ADDENDUM NO. 1
November 17, 2020
224888

RE: TOWN OF ROXBURY, VERMONT
ROXBURY TH-1 PERMANENT SLOPE STABILIZATION ER 0188(11)

FROM: DuBOIS & KING, INC.
6 Green Tree Drive
South Burlington, Vermont 05403
(802) 728-7208

SHEET TITLE
PROPOSED SITE SHEET 1

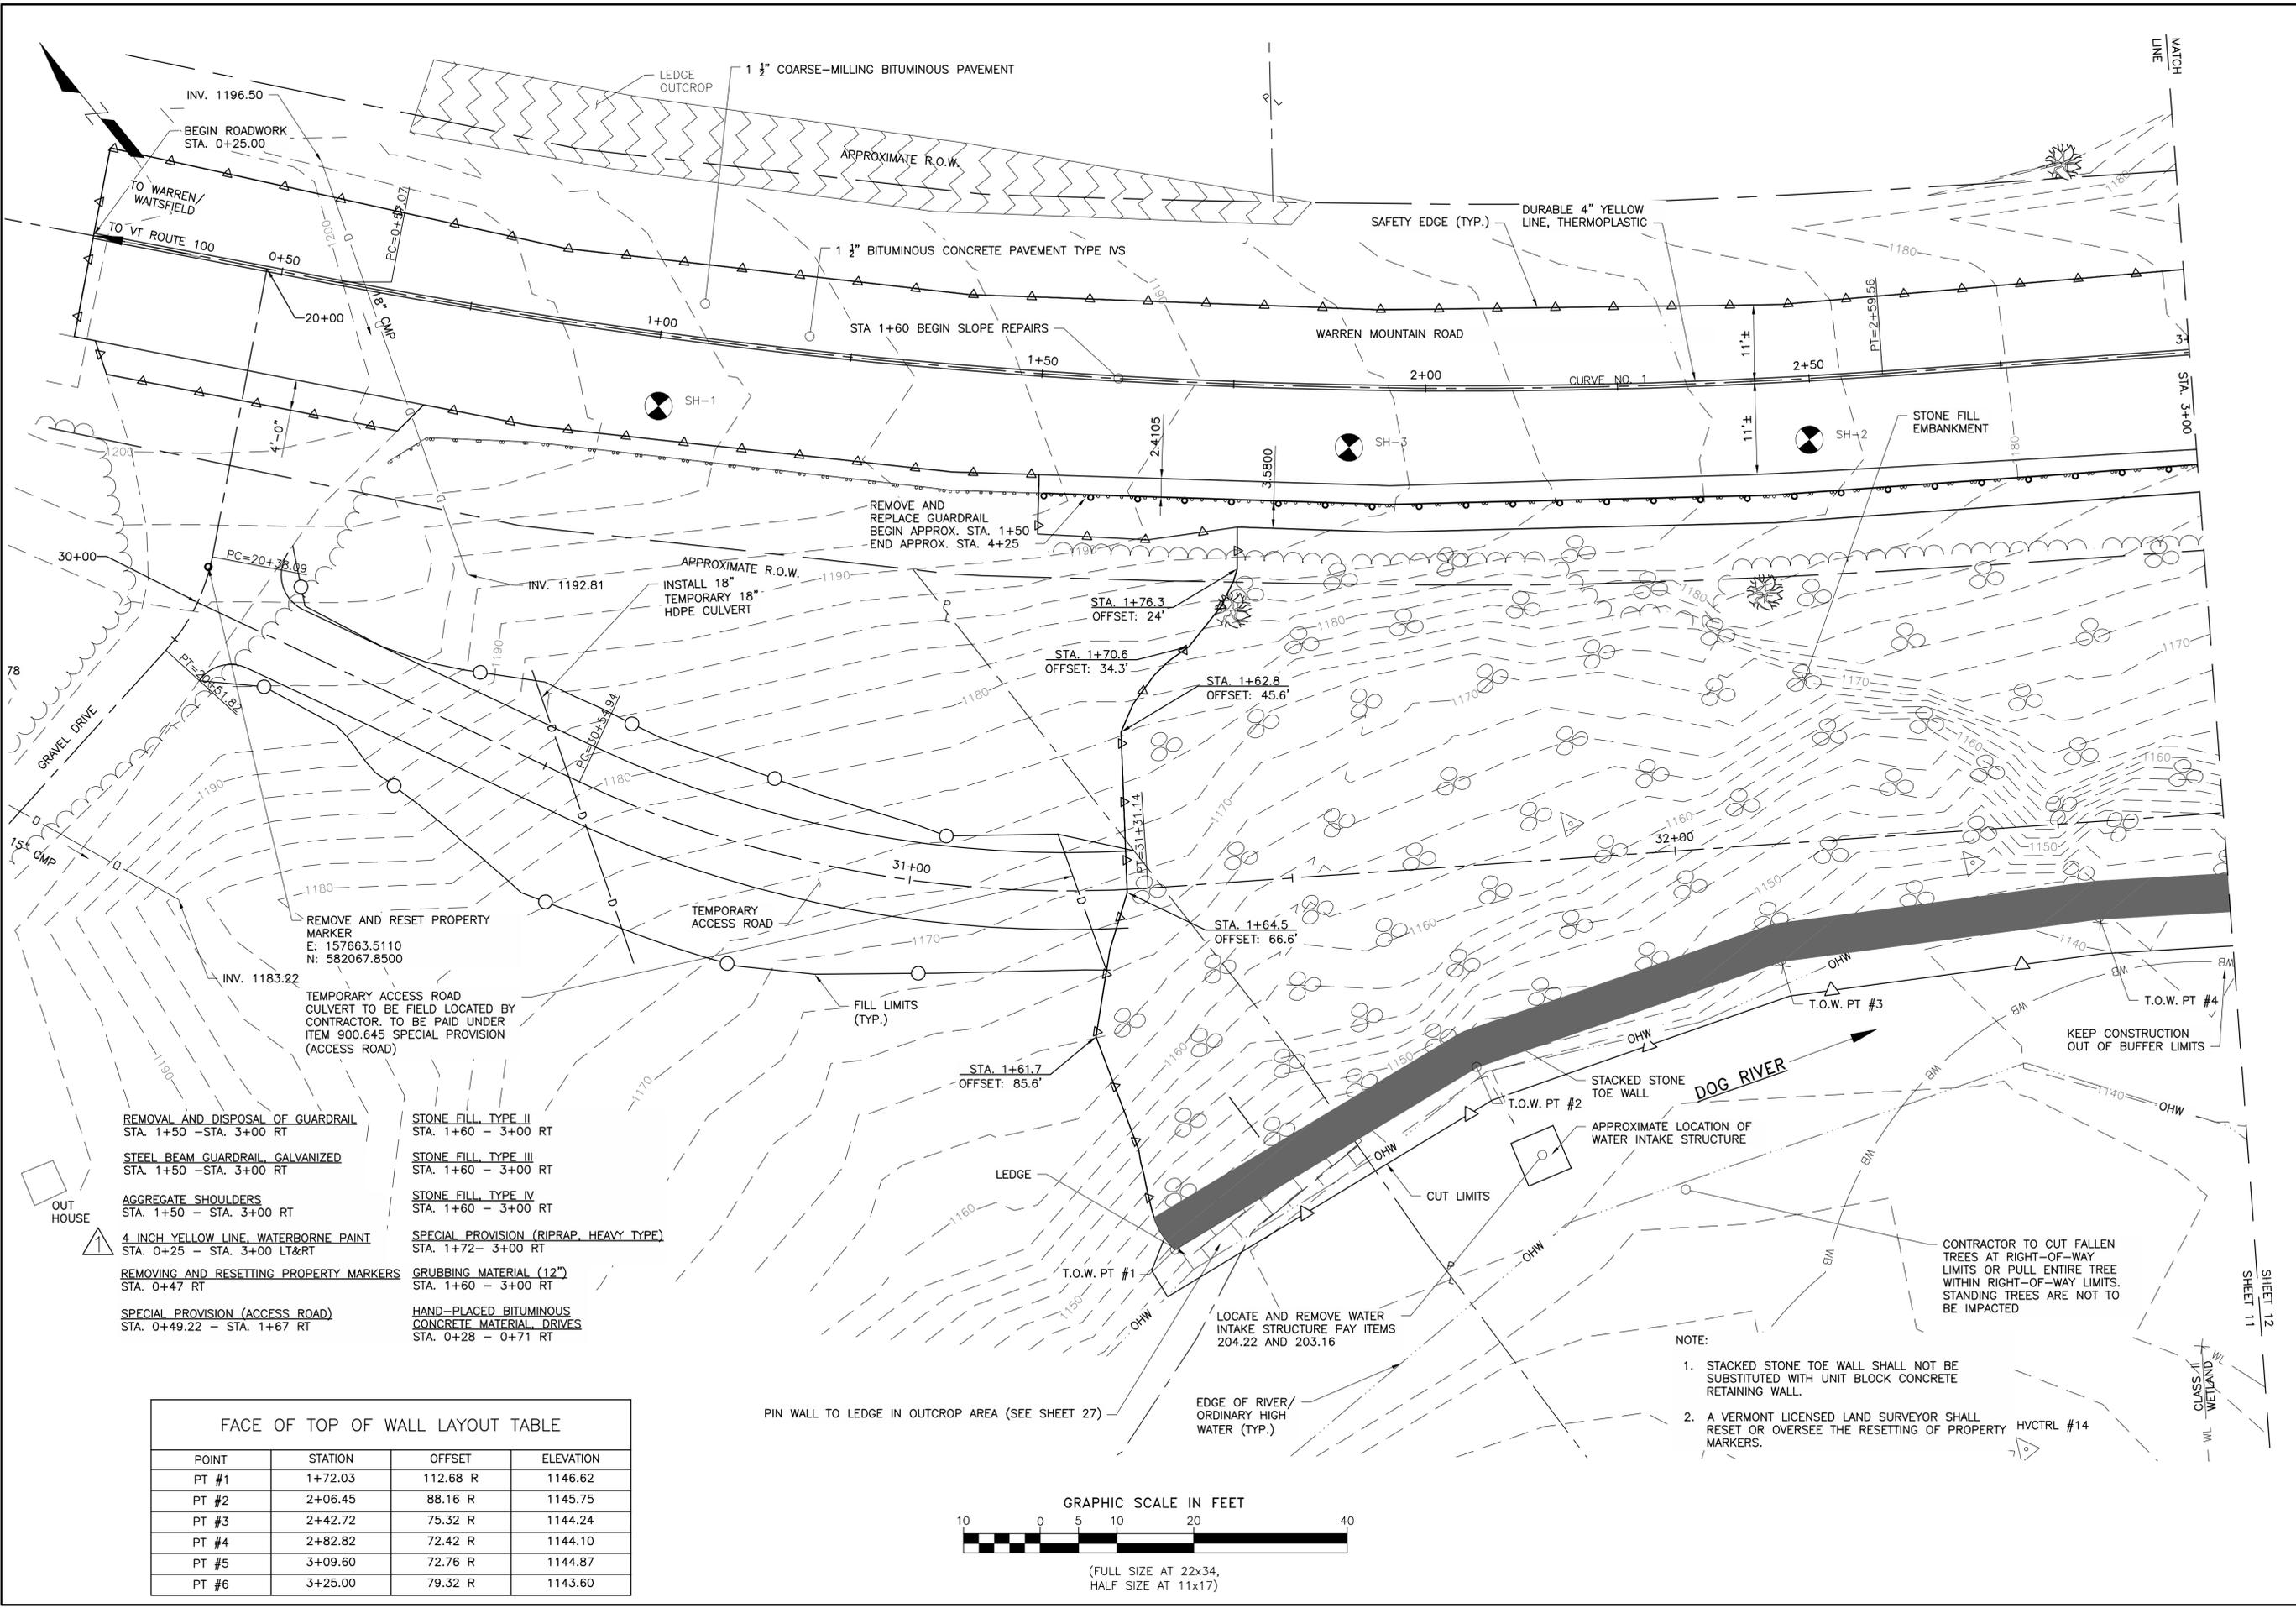
- REMOVAL AND DISPOSAL OF GUARDRAIL STA. 1+50 - STA. 3+00 RT
- STEEL BEAM GUARDRAIL, GALVANIZED STA. 1+50 - STA. 3+00 RT
- AGGREGATE SHOULDERS STA. 1+50 - STA. 3+00 RT
- 4 INCH YELLOW LINE, WATERBORNE PAINT STA. 0+25 - STA. 3+00 LT&RT
- REMOVING AND RESETTING PROPERTY MARKERS STA. 0+47 RT
- SPECIAL PROVISION (ACCESS ROAD) STA. 0+49.22 - STA. 1+67 RT
- STONE FILL, TYPE II STA. 1+60 - 3+00 RT
- STONE FILL, TYPE III STA. 1+60 - 3+00 RT
- STONE FILL, TYPE IV STA. 1+60 - 3+00 RT
- SPECIAL PROVISION (RIPRAP, HEAVY TYPE) STA. 1+72 - 3+00 RT
- GRUBBING MATERIAL (12") STA. 1+60 - 3+00 RT
- HAND-PLACED BITUMINOUS CONCRETE MATERIAL, DRIVES STA. 0+28 - 0+71 RT
